DSP-21033

Metropolitan East at Konterra Town Center

STAFF REPORT

SUBJECT: Detailed Site Plan DSP-21033
Type II Tree Conservation Plan TCPII-065-08-03
Metropolitan East at Konterra Town Center

Figure 4: Signage

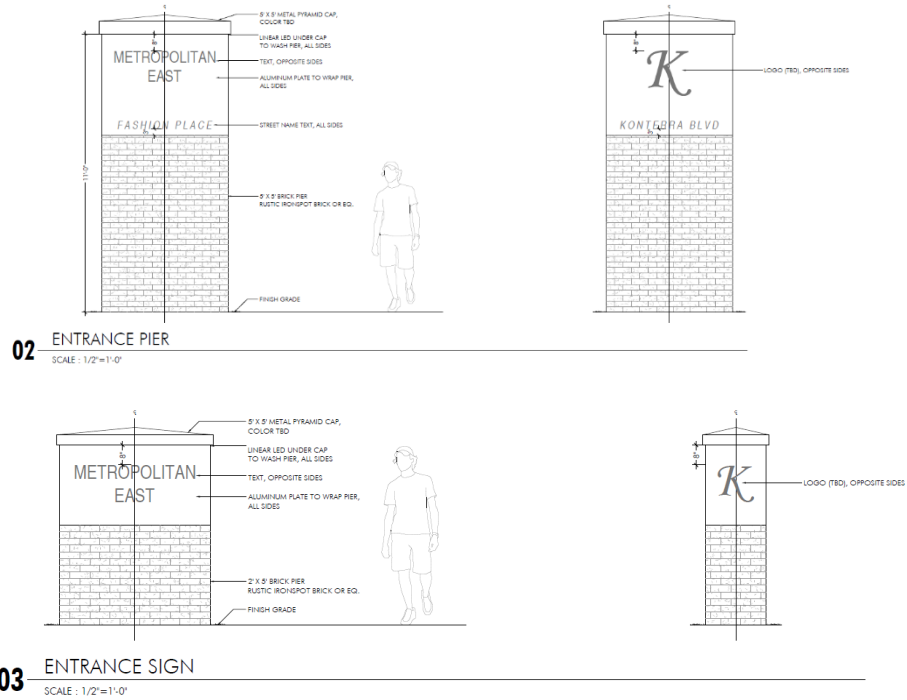
Eight freestanding entrance signs and two freestanding piers are located on-site. The 5-foot-wide freestanding entrance signs are brick columns, which are located at the entrances to the public roads and are approximately 6 feet tall. The signs include a metal cap with downward facing LED lighting to illuminate the name of the development. The piers are designed in a similar fashion and are located on the north and south sides of Fashion Place, at its intersection with Konterra Boulevard East. The 5-foot-wide piers are 11 feet tall and include a logo and the name of the development. The sign is acceptable; however, staff recommends that attractive year-round landscaping be proposed at the base of the signs and the piers to provide seasonal interest, and a condition requiring this has been included herein.

- q. Provide attractive year-round landscaping at the base of the piers and entrance signs.
 - r. Provide pet waste stations along proposed trails within this DSP.
